REGIONAL REVIEW NOTIFICATION

Name of Proposal: Continuum Alpharetta DRI 3508

CONTINUUM ALPHARETTA DRI City of Alpharetta Natural Resources Group Review Comments

DRI SITE PLAN

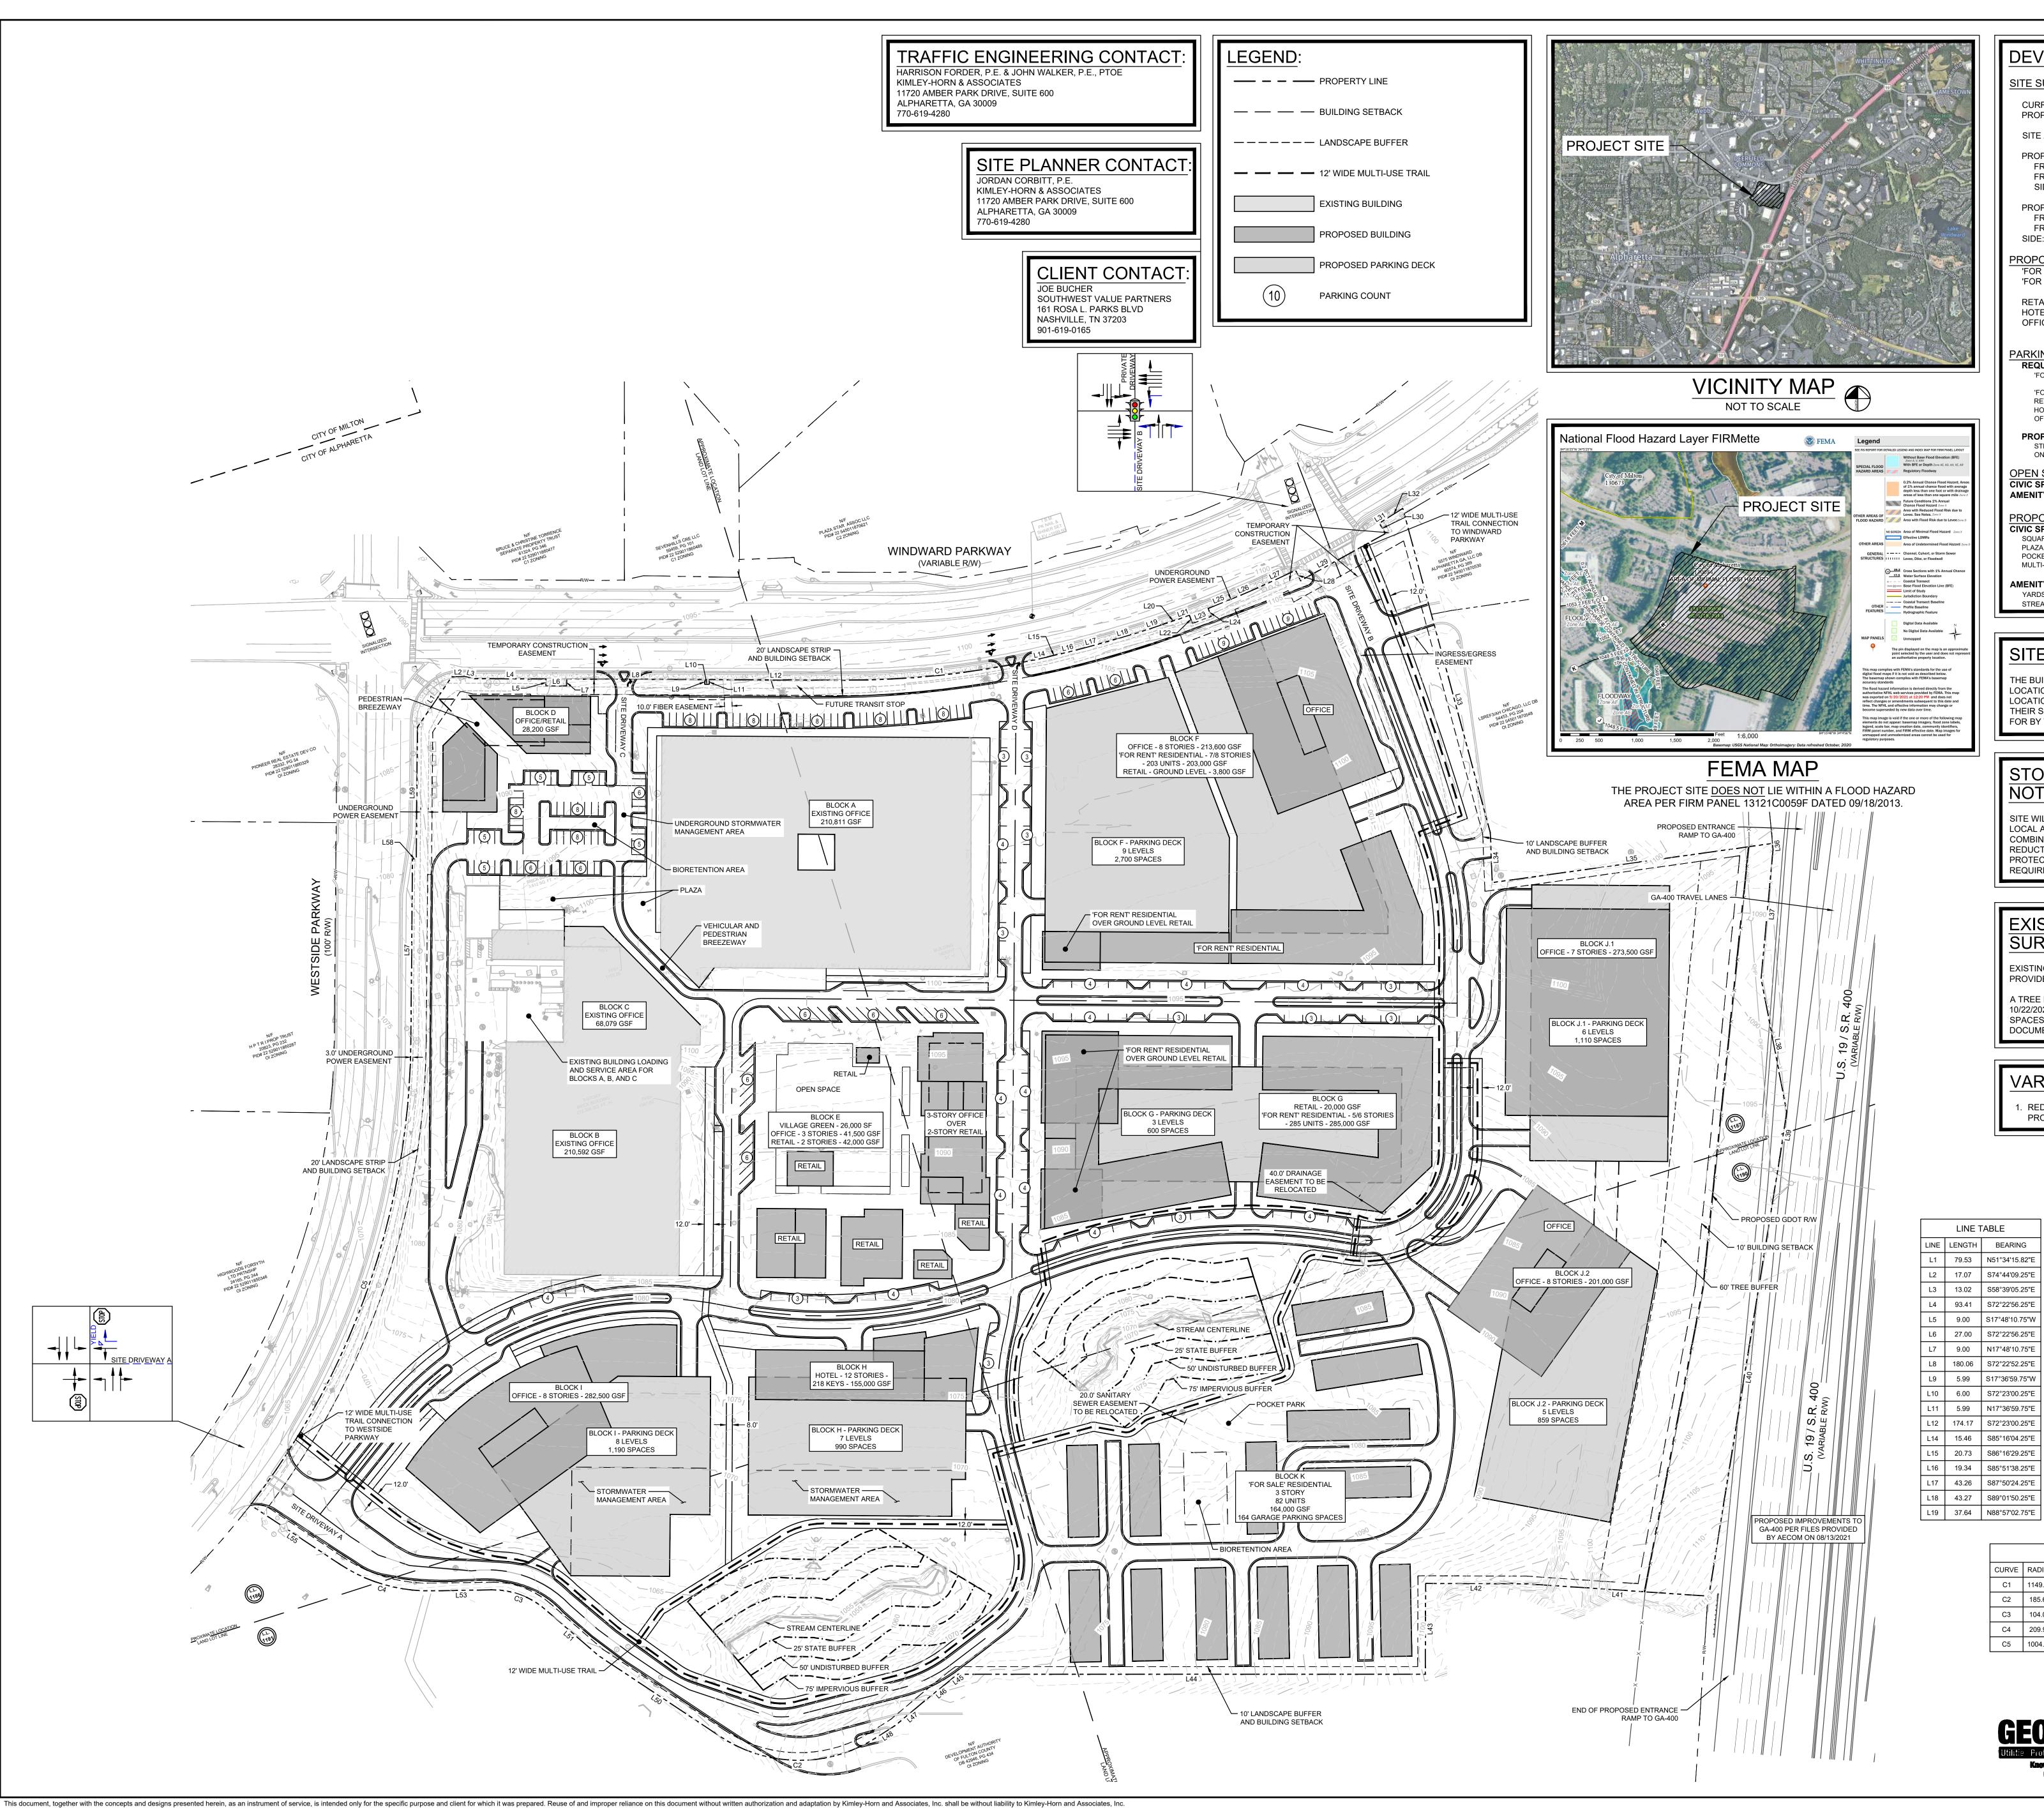
The wide breezeway in between the retail buildings at the NW corner of the site creates an inviting pedestrian access point; ideally it should extend all the way to the sidewalk at the Windward/Westside Parkways intersection. Widening of the sidewalk around this corner could further emphasize this important pedestrian connection and placemaking element. The intersection of the internal 12 ft wide trail with Westside Parkway provides a similar key pedestrian entrance and placemaking opportunity. Ideally there could be a third similar pedestrian access point/feature at Driveway D along Windward Parkway.

The interior access road and perpendicular parking proposed along the Windward Parkway frontage seem more suited to a retail strip mall than to a large mixed-use development. Ideally this area could be revised to create a better street edge and pedestrian environment along Windward Parkway.

The 12-foot-wide multi-use trail linking the center of the site with the Windward and Westside Parkway frontages is a highly desirable aspect of the project. There are several opportunities for connecting this segment of trail within the project to the evolving nearby regional trails. There is a planned project to extend the Big Creek Greenway from its current access point at Marconi Drive and Windward Parkway to the intersection of Cogburn Road and Bethany Bend. This extension would cross Morris Road just north of Old Morris Road; from that point it would be short distance to connect to Windward Parkway and the project via the crosswalk at Driveway B. Another connection opportunity would be to the south from the Driveway A along Westside Parkway to Academy Street/Webb Bridge Road which is the site of the future outer loop segment of the Alpharetta Loop Trail. These short extensions would dramatically increase the span and connectivity of both the Alpharetta Loop and Big Creek Greenway trails.

The USGS coverage for the project area shows no blue-line streams on the project property. The submitted site plan shows two segments of a tributary to the blue-line stream crossing the project property. No intrusions are shown in the mapped buffers. Any intrusions proposed in these buffers may require variances. The proposed preserved natural areas around the stream tributary are highly in keeping with regional stormwater management, tree preservation, and carbon management goals. There are several areas on the plan noted as "stormwater management area" but seem to fall within a building footprint of the Block H and I parking decks. Ideally the parking can be reduced through the shared parking reduction option and the size of some the parking decks can be reduced accordingly.

The re-use of the existing large surface parking areas is also highly supportive of regional stormwater and redevelopment goals. There are large areas of existing trees that are proposed for clearing and development in the areas of Blocks D, J2, and K; ideally the bio-retention and parking area shown in the surface parking at Block D could incorporate existing trees. Additional retention of existing stands of trees would be desirable and in keeping with regional goals regarding carbon sequestration and climate change/heat island effect mitigation.
